Revision information for D80_nnn.exe firmware

Model	Interface	SRAM required	CPU speed	Version
iP-8411,iP-8811	RS-232/RS-485	512K bytes	80MHz	D5.xx

D5.04[2014-Dec-11] by Martin

Host PC1 can configure backplane I/O via iP-8411 COM1

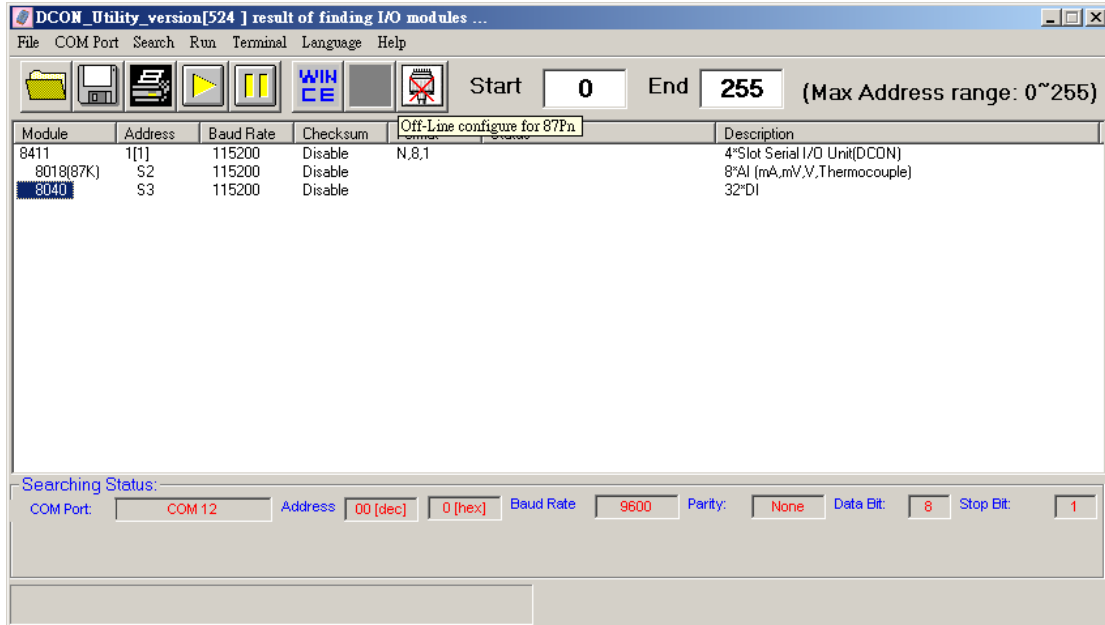
In the same time, users can configuration backplane modules via iP-8411/iP-8811 COM1/COM2/COM3/COM4 for single or multi Host PC

For example: Host PC1 can configure backplane I/O via iP-8411 COM1 and Host PC2 also via iP-8441 COM2 in the same time.
